Subject: Borg-Warner 3" and 4" Swing Check Valves

10 CFR PART 21 NOTIFICATION

(Reference No. CFRN-9301)

Texas Utilities, Comanche Peak Steam Electric Station.  
Basic Component: 4-inch 150# Bolted Bonnet Swing Check Valve  
BW/IP Part No. 75580  
TU Tag Nos. 2CC-0697 & 2CC-0693

Required Angle of Disc Rotation and Axial Gap for Interference

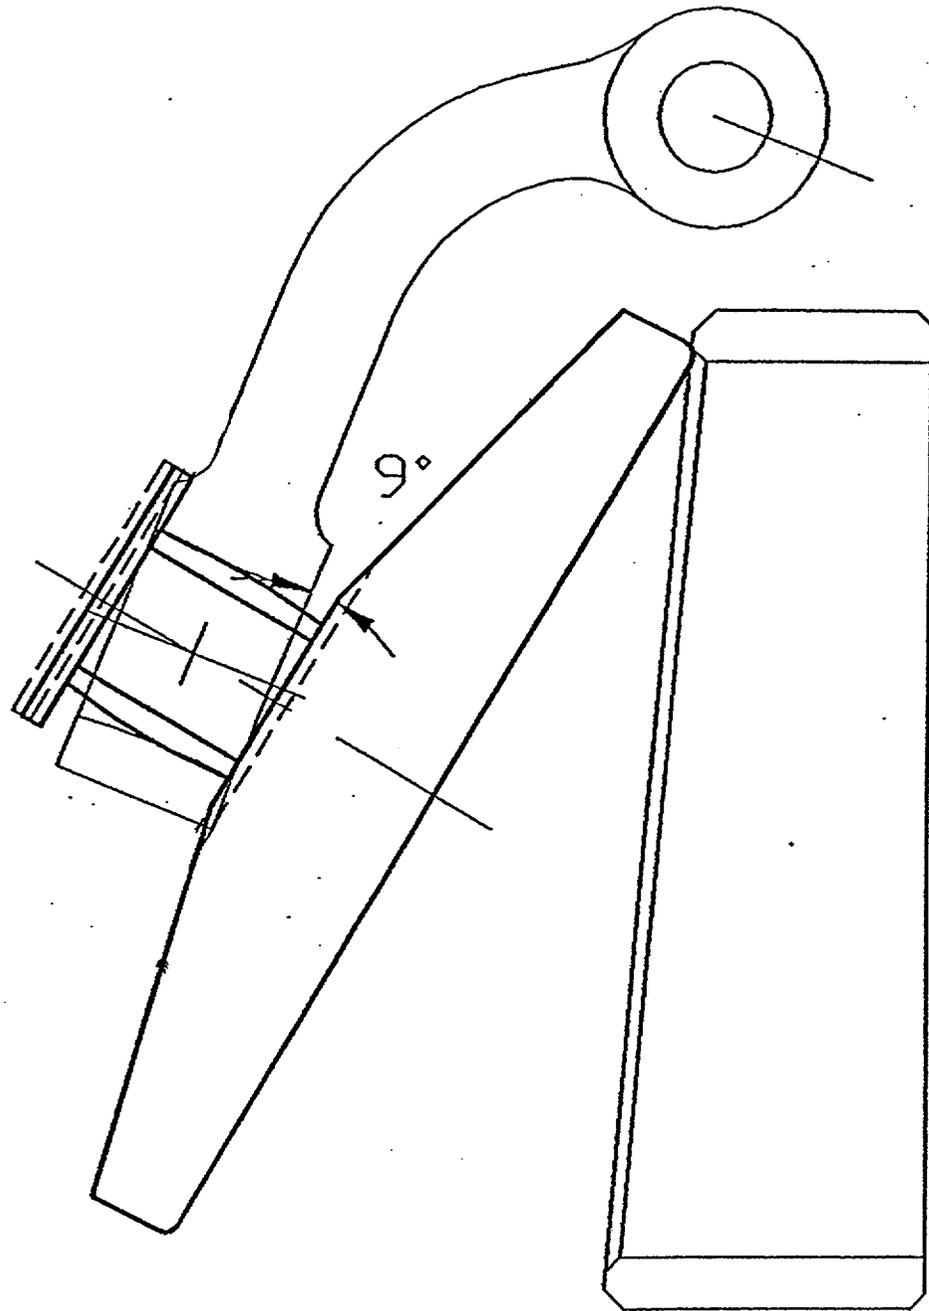
Valve 2CC-0697 did not fully close during pre-operational testing. Radiographs taken at the time of failure show the disk positioned at approximately 21° from the full closed position. The valve was disassembled. The top of the disk was found to be lodged under the seat lip preventing full closure. Valve 2CC-0693 subsequently failed testing in a similar manner. Both valves are located in the Component Cooling Water return lines from the Reactor Coolant Pump Motor Coolers and do not serve an active safety function. However the failure mechanism could apply to other valves that do provide a safety function.

Evaluation of the basic component by BW/IP indicates the root cause of the failure to close is due to the configuration of the attachment weld between the disk to the stud. Prior to 1977, this weld was placed on the back surface of the stud and extended into the bushing bore. In disks manufactured after 1977, the weld was recessed into the back surface of the disk and a final machine cut made to assure a flush surface.

This notice applies to all BW/IP 4-inch, 150#, bolted bonnet swing check valves which have a raised disk-stud retention weld on the back surface of the disk.

Corrective action is complete with the disk design modification identified above.

Licensees with valve installations effected by this notice should install a new disk component or refurbish the existing disk.
